RE: Request for Rail Clearance Waiver

The Port of Tacoma maintains rail tracks that cross 11<sup>th</sup> street on the North side [See Illustration 1/12; 2/12, attached]. Due to recent emphasis on security concerns, the Port of Tacoma has been hardening its secure perimeter. Running parallel to 11<sup>th</sup> street and crossing rail tracks, this perimeter will take the form of hydraulically operated gates at the rail crossings installed in an existing 8' steel fence..

2/12

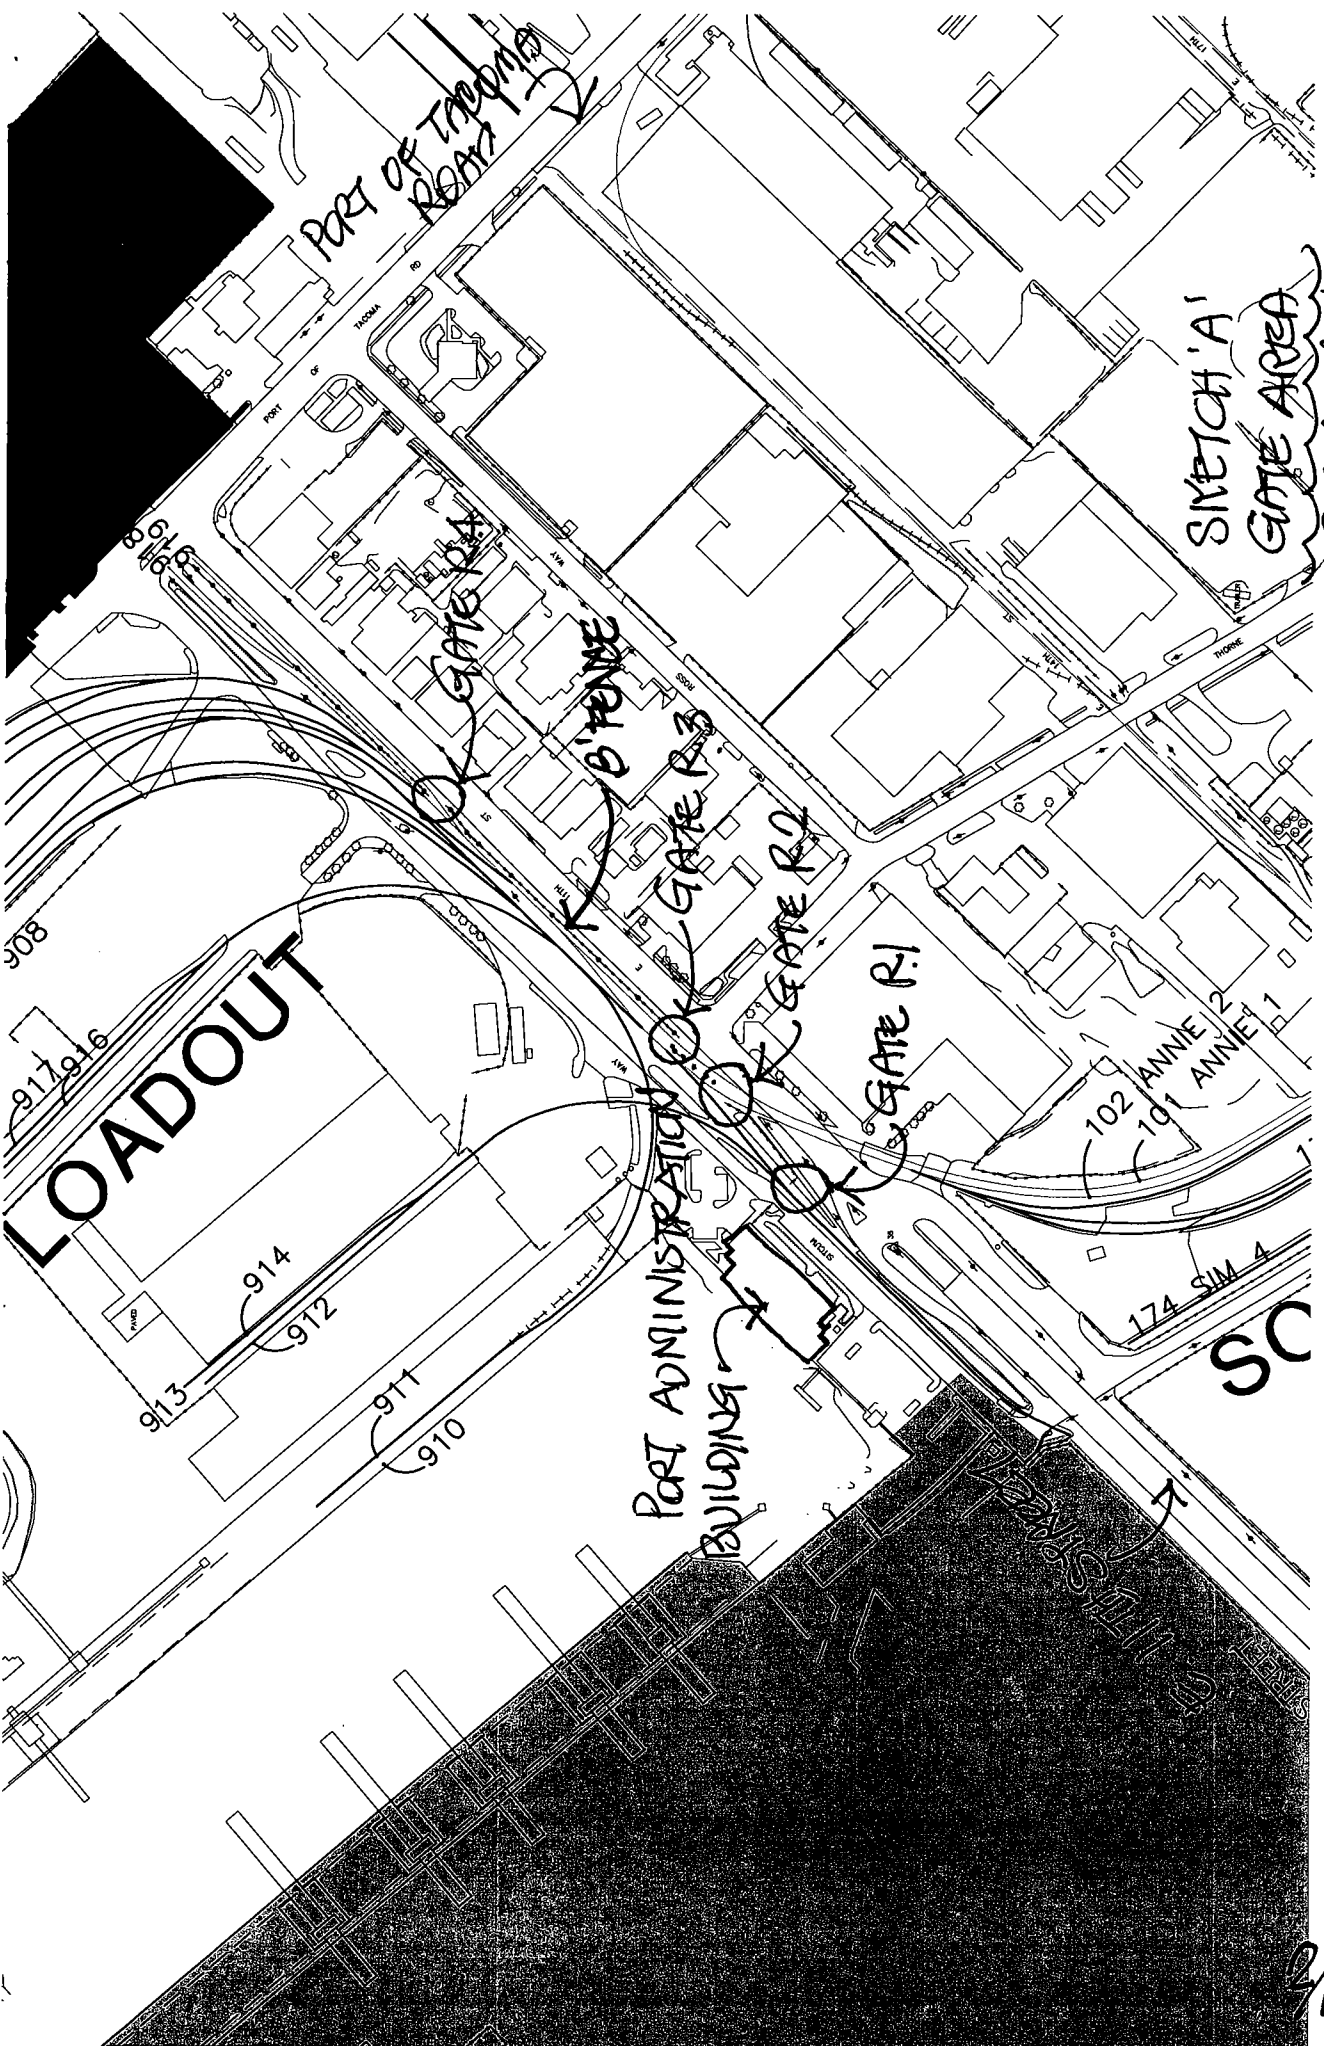
There are four gates in question [See Illustration 2/12], three of which I do not believe to represent any clearance problems [R1, R2 and R3].

6/12

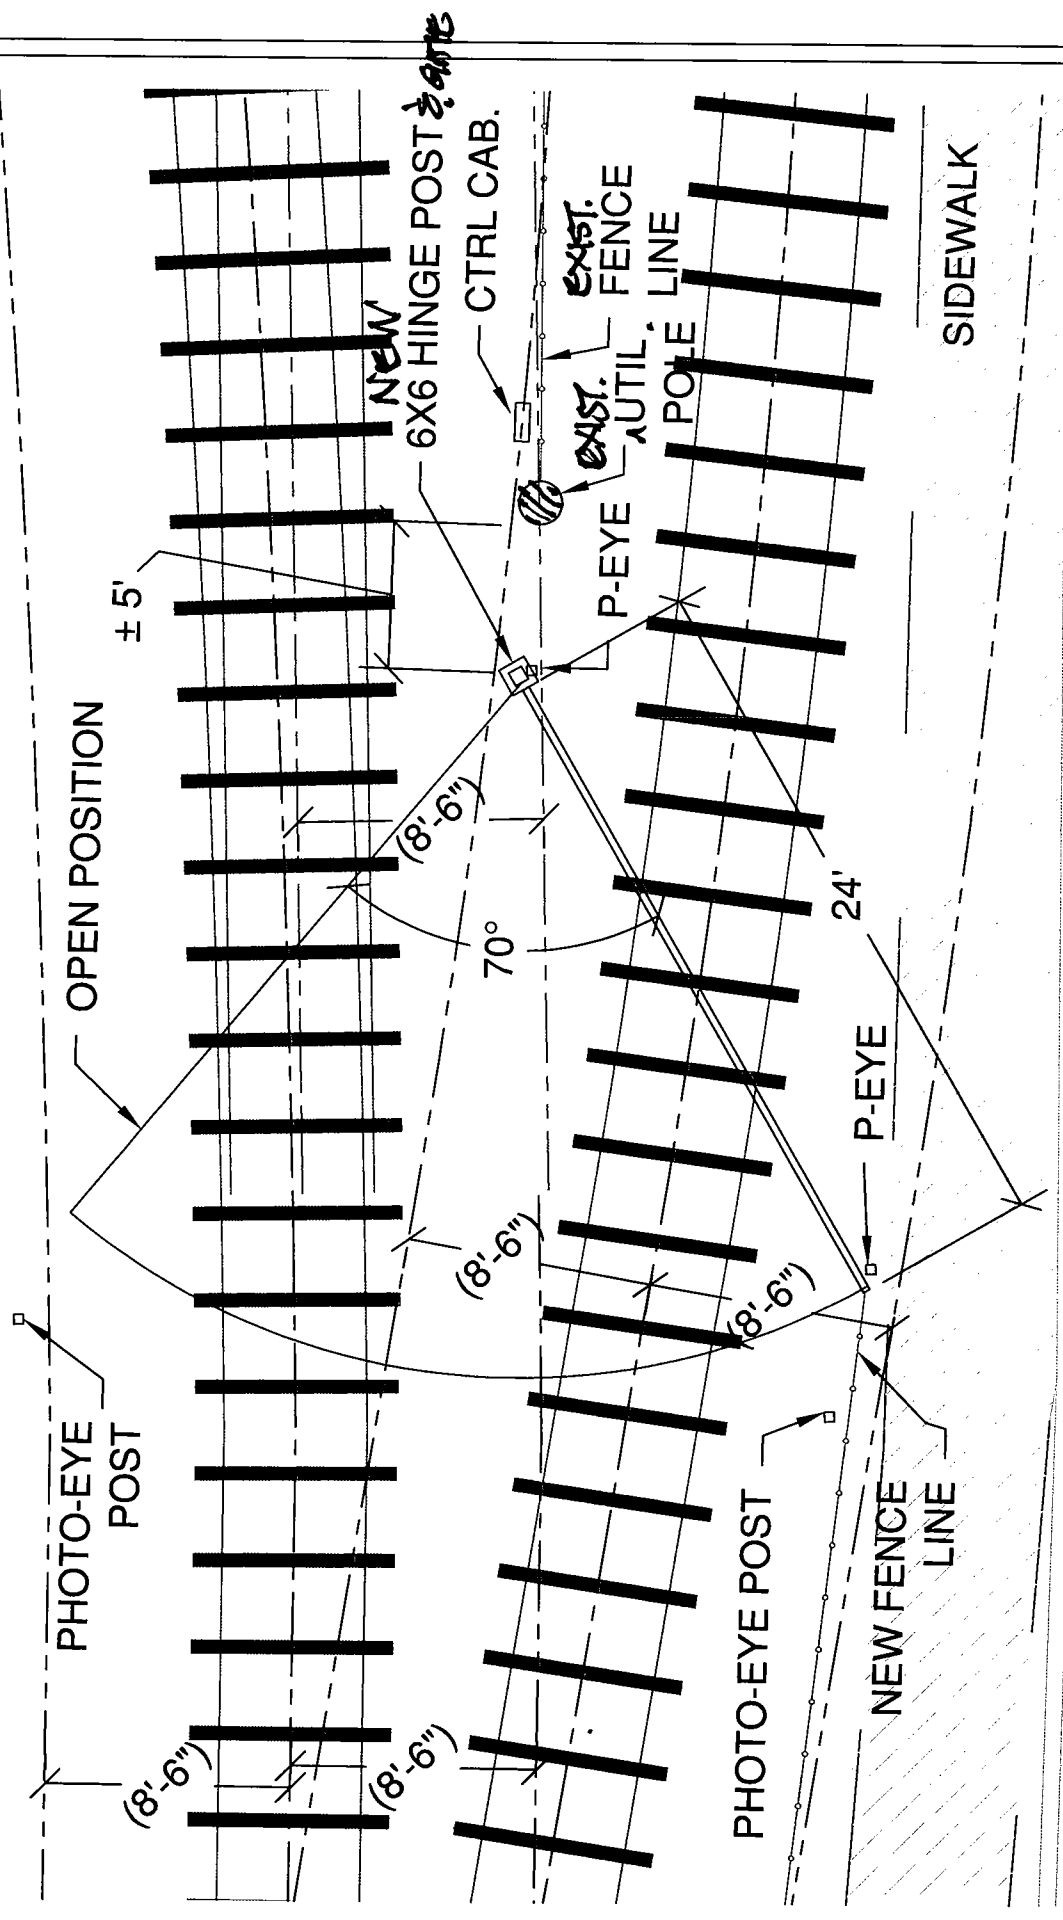
This letter is to request a waiver for the installation of Gate R4. The logic we are offering is that while this gate falls within 8'-6" established from center of rail to obstruction, this gate does not exceed those clearances established with the existing power pole that has existed in this location for decades. [See Illustration 6/12; Photographs 10/12 and 12/12.]

10/12

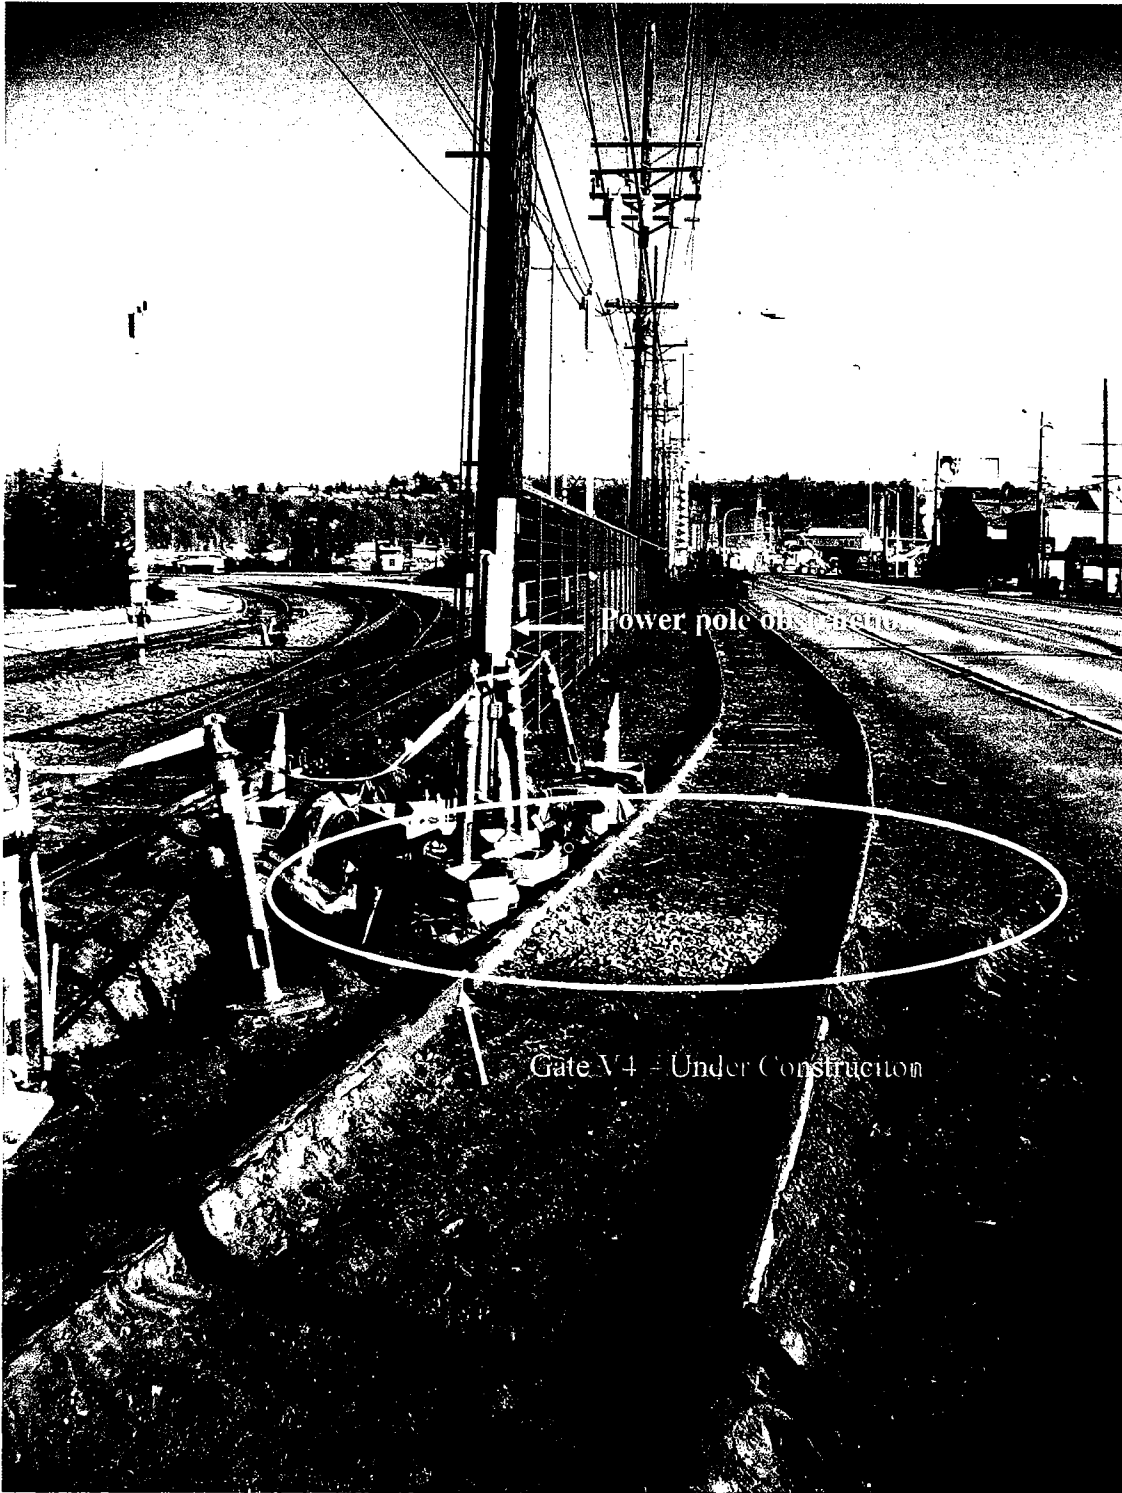
However, the gate identified as R4 crossing a rail spur and utilized infrequently [twice a week or so], appears to represent a clearance problem. This rail spur historically appears to represent a clearance problem as old signage identifies a power pole as being a hazard [See Illustration 10/12; 12/12].
